Request	-	Special Use Permit for a Scrap & Salvage Facility
Location	-	4103 Lagrange Street
Applicant / Owner	-	Jonke Real Estate 4103 Lagrange Street Toledo, OH 43612
Civil Engineer	-	Verdantas 219 South Erie Street Toledo, OH 43604

The staff recommends that the Toledo City Plan Commission recommend approval of SUP26-0011, a Special Use Permit for a Scrap & Salvage Facility at 4103 Lagrange Street, to Toledo City Council, for the following **two (2) reasons**:

SPECIAL USE PERMIT
TOLEDO CITY PLAN COMMISSION
REF: SUP26-0011
DATE: April 9, 2026
TIME: 2:00 P.M.

SITE PLAN

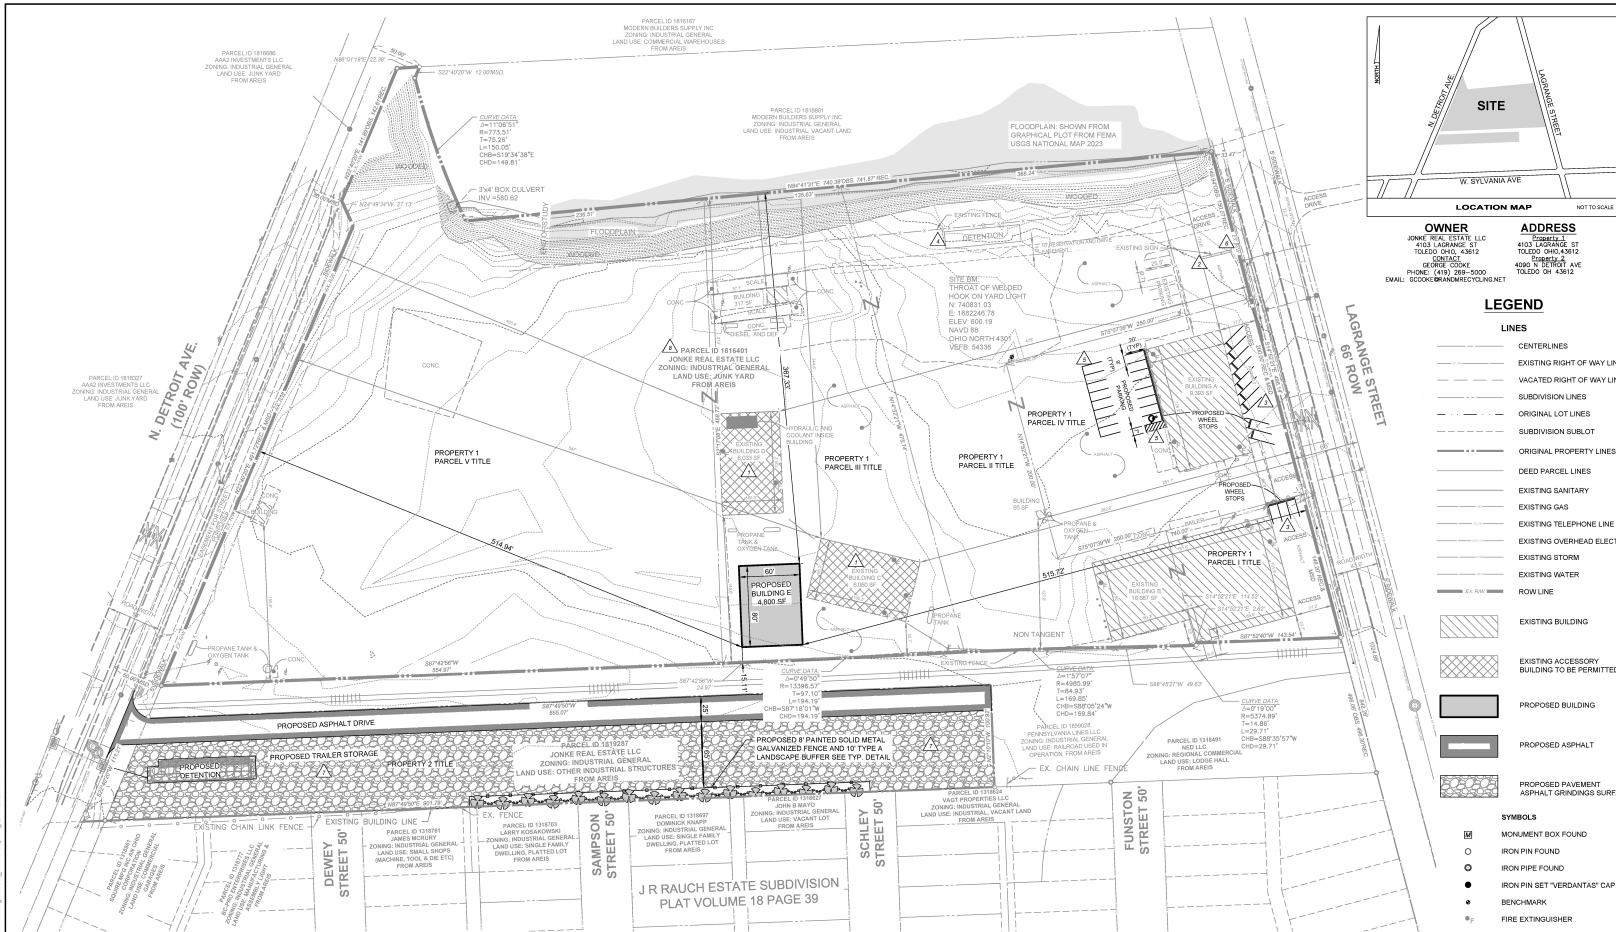
It is unclear if the proposed parking spaces meet the dimensional requirements of TMC§1107.1911 because they are not all clearly dimensioned. The applicant shall submit a revised site plan clearly dimensioning all parking spots, driveways, and drive aisles, ensuring compliance with TMC§1107.1911.

21. Bicycle parking is required per TMC 1107.0900.
22. One van accessible parking space with an 8' loading aisle and one auto accessible parking space with a 5' loading aisle is required per TMC 1107.1701 & 1107.1702. (The van loading aisle is not the right size.)

25. Two-way drive aisle in rear parking is required to be a minimum of 25' wide for two-way traffic per TMC 1107.1911.
26. All angled parking must be angled the same direction with ground painted arrows for one-way traffic pattern per TMC 1107.1911.

32. A Type A buffer meeting the requirements of TMC§1108.0203 shall be installed along the southern property line adjacent to residential uses and extending eastward to the eastern property line. **Not acceptable as depicted. The applicant shall submit a revised site / landscape plan depicting a Type A buffer along the southern property line adjacent to residential uses and extending eastward to the eastern property line.**

34. Per TMC§1108.0202, a frontage greenbelt shall be installed along Detroit Avenue. One (1) tree is required for every thirty feet (30') of frontage. Existing trees may be used as credits per TMC§1108.0407. **Not acceptable as depicted. The applicant shall submit a revised site / landscape plan depicting frontage greenbelt plantings along Detroit Avenue.**

36. Parking spaces to be removed shall be shown on a "final" site plan. Such removed parking areas shall be physically removed by way of pavement removal. This pavement removal shall also be depicted on a "final" site plan. **Applicant shall submit a revised site plan depicting the proposed removal of parking spaces.**

37. Per TMC§1107.1906, all off-street parking, loading spaces, parking lots, maneuvering areas, drive aisles and driveways must be surfaced with concrete, asphalt or other dust-free materials other than dirt, gravel or loose fill. **Applicant shall submit a revised site plan depicting which portions of the site are paved pursuant to TMC§1107.1906. Should portions of the site be unpaved, the applicant will either need to pave these areas or obtain a variance from the Board of Zoning Appeals.**
